Serial No. : 10/762,793  
Filed : January 22, 2004

REMARKS

Fig.1 (Prior Art)

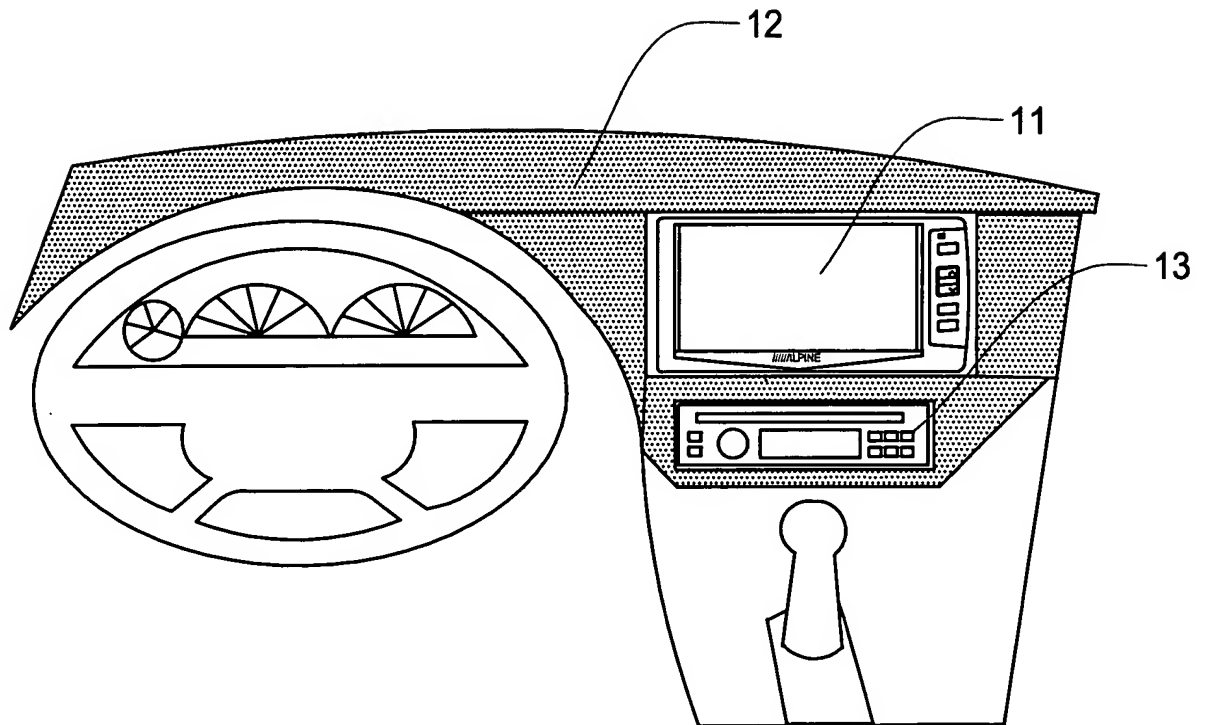
The examiner objected to the drawings on the ground that Figures 1, 3, 4A and 4B lack designations as prior art. Accordingly, the applicant has submitted concurrently herewith a request for approval of drawing changes in which a "Prior Art" label is added to Figures 1, 3, 4A and 4B. The applicant has also submitted replacement sheets for the amended drawings.

The applicant has submitted concurrently herewith a request for approval of drawing changes in which a "Prior Art" label is added to Figures 1, 3 and 4A-4B. The applicant has also submitted replace sheets for the amended drawings.

Fig. 4A (Prior Art)

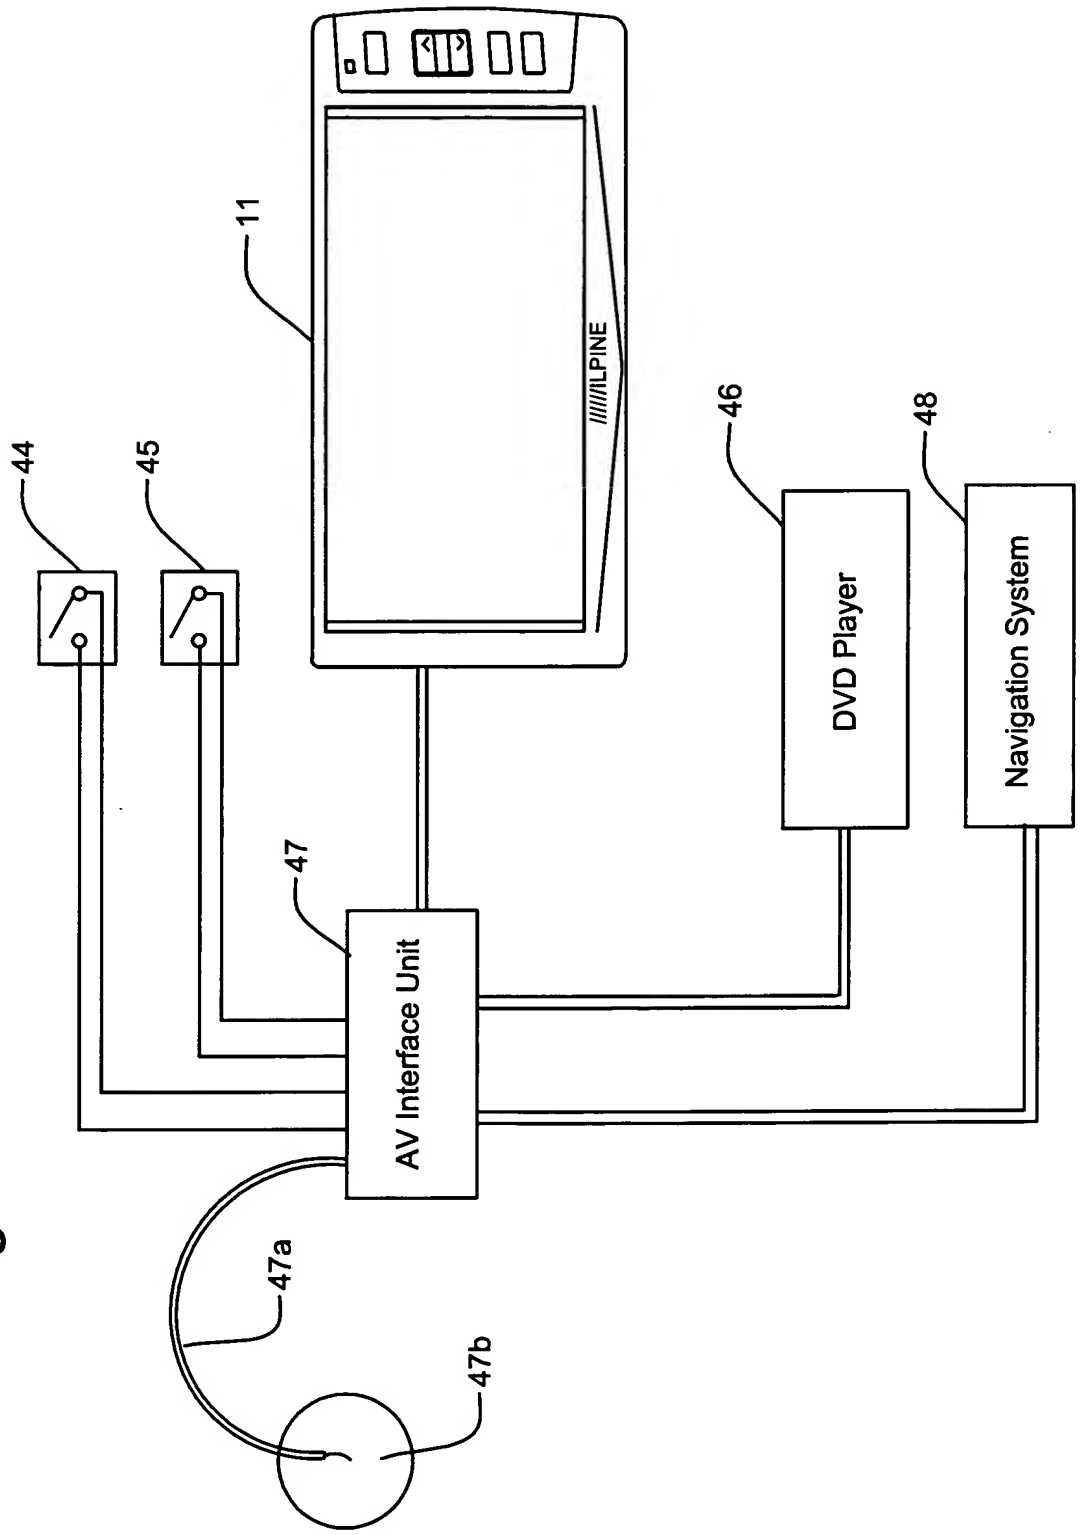
The admitted prior art shown in Figure 4A needs a wire for connecting the AV interface unit 47 to the ground to release the brake interlock function. As known in the art, in the application to a vehicle, the ground is a body frame of the vehicle. Thus, in the admitted prior art, the wire (release device) cannot be established within the display compartment formed on the front or
